MORRISON-KNUDSEN COMPANY, INC.

LTR-QTS-85-013

MESSAGESUBJECT: TVA-SEQUOYAHENGINE GOVERNOR ACTUATOR ELECTRICAL CONNECTING PLUG

MORRISON-KNUDSEN COMPANY, INC.
POWER SYSTEMS DIVISION10CFR21-002710CFR21 COMMITTEE MEETING HELD SEPTEMBER 6, 1985

FIG-1

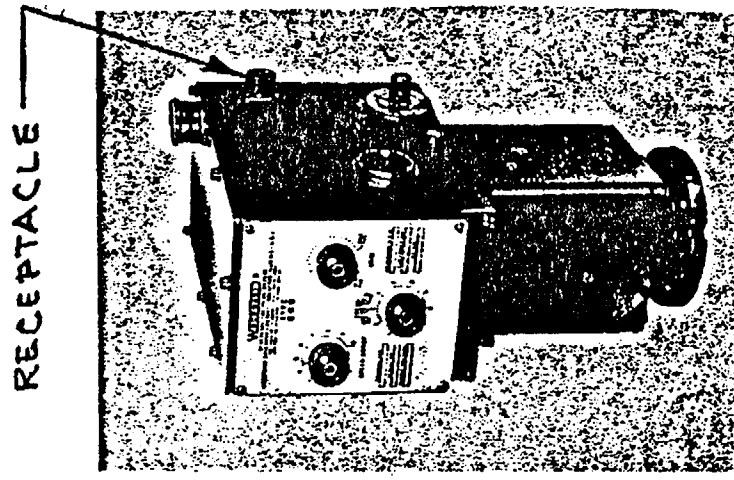
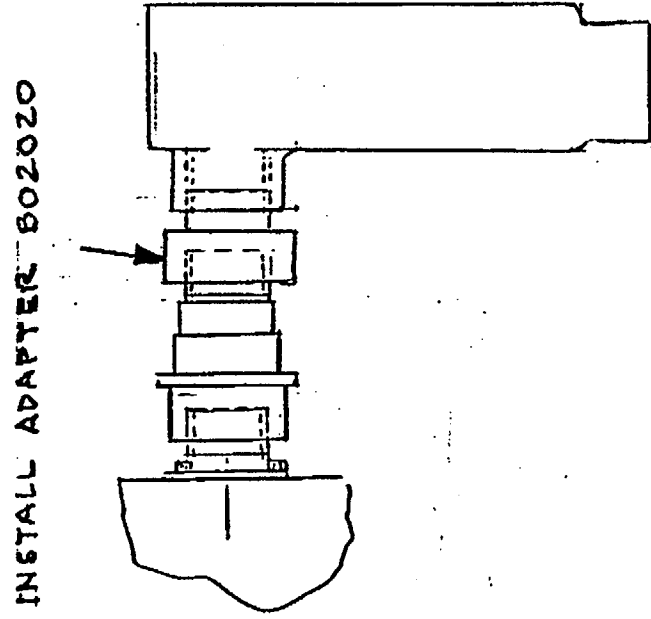
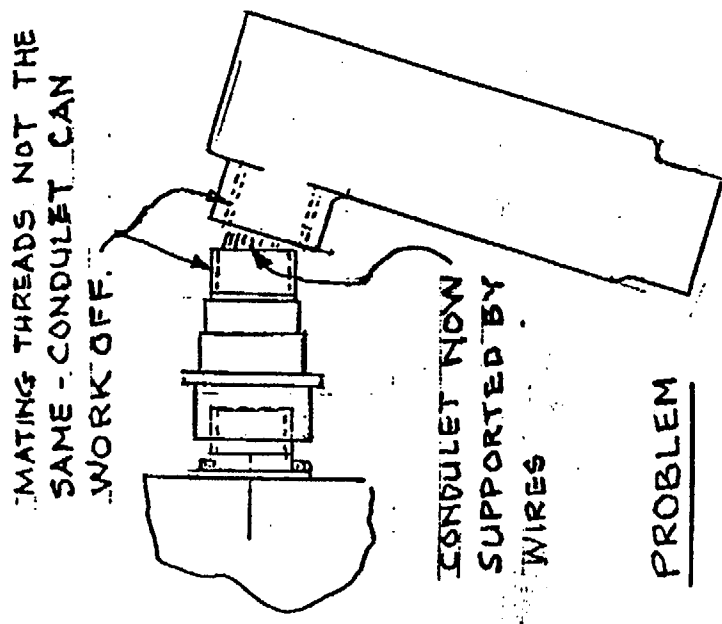
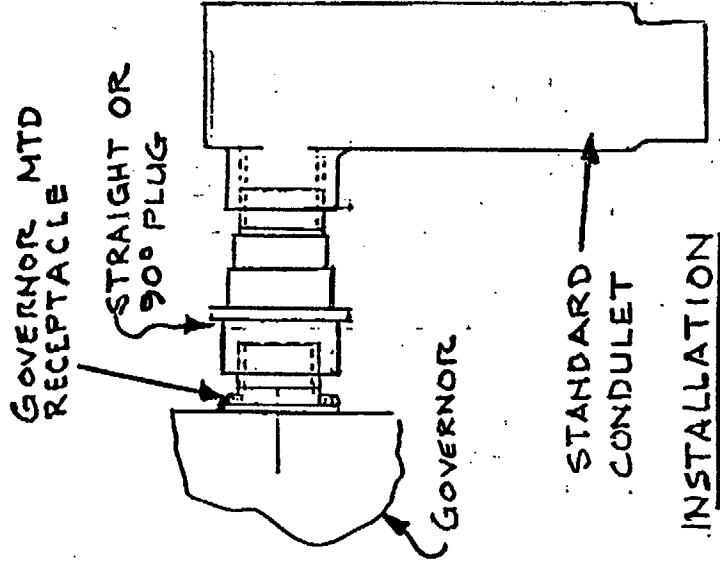
Improper threads on electrical thread connectors to flexible conduit.

Fig. 1 illustrates the problem. The governor actuator is mounted on the diesel engine. A typical governor is shown in Fig. 1 on which an electrical receptacle is identified. All the electrical signals for the electric portion of the governor, the hydraulic governor speed setting motors, the shutdown solenoid and limit switches are supplied through this receptacle.

For diesel-generators furnished prior to 1976, the arrangement as shown on Fig. 1 "Installation" may have been furnished showing the connections to this receptacle. The problem is that the threads in the conduit are not the same as the mating threads on the plug. While the assembly appeared to be tight, there is a potential for the thread joint to loosen, particularly when subjected to engine operating vibration, with the conduit eventually working free. Then the only support for the flexible conduit that connects the plug to the control panel is the control wires inside. The potential then exists for the possible shorting or breaking of wires as a result of operating vibration; thereby, interrupting the signals to the governor and preventing the diesel-generator from performing its safety function.

The corrective action is to install an adapter P.N. B02020 which provides the correct threads for each component.
